LaSalle County Station, Units 1 and 2  
Facility Operating License Nos. NPF-11 and NPF-18  
NRC Docket Nos. 50-373 and 50-374

**Subject:** Additional Information Supporting the Request for a License Amendment to Revise Local Power Range Monitor Calibration Frequency

### Additional Information Supporting the Request for a License Amendment to Revise Local Power Range Monitor Calibration Frequency

**Figure 1**  
**Calibration Current for LPRM #344**

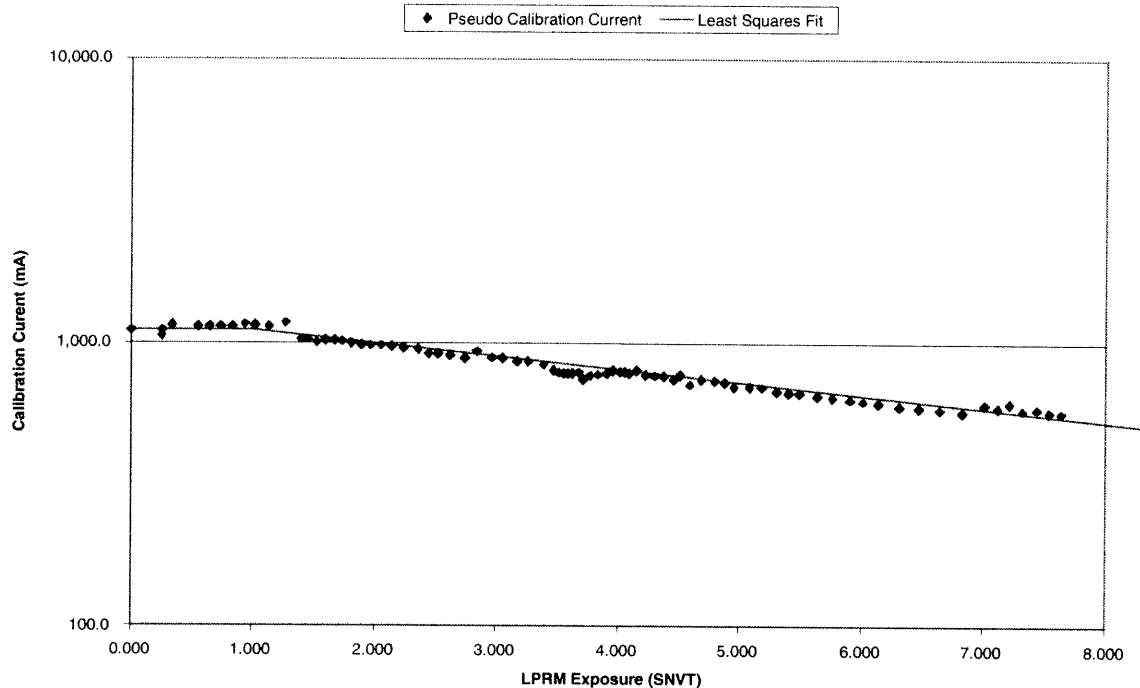
- 1.3. *Explain how the LPRM decay factor was obtained and provide an example calculation to show the result of the calculated decay factor from the exposure data for one LPRM. Also, provide information to demonstrate that the value specified in the attachments is adequate for determining the LPRM uncertainties.*

The uncertainty analysis was done for a fixed decay factor value of -0.092 for both units. By choosing a fixed sensitivity, one expects to maximize the uncertainty in the predicted response. The actual value currently in use for core monitoring is -0.1189.

Different decay factors were used to evaluate the impact on the uncertainty results. The results showed that the uncertainty increase is not very sensitive to different decay factors. In other words, the change in the predicted calibration uncertainties is independent of the choice in a fixed

decay constant. However, the analysis based on the plant LPRM calibration history data indicates that the decay factor used in the POWERPLEX-III input deck should be adjusted for 2500 EFPH extended calibration interval to be consistent with the plant historical data. Therefore, the POWERPLEX-III input deck will be adjusted as part of the implementation actions associated with this amendment. The average decay factors calculated from actual plant data are -0.10 for both units.

The average decay constant value is determined by performing a least squares fit of the logarithm of the actual calibration currents as a function of detector exposure (SNVT). The data is illustrated in Figure 1 for an individual LPRM detector.
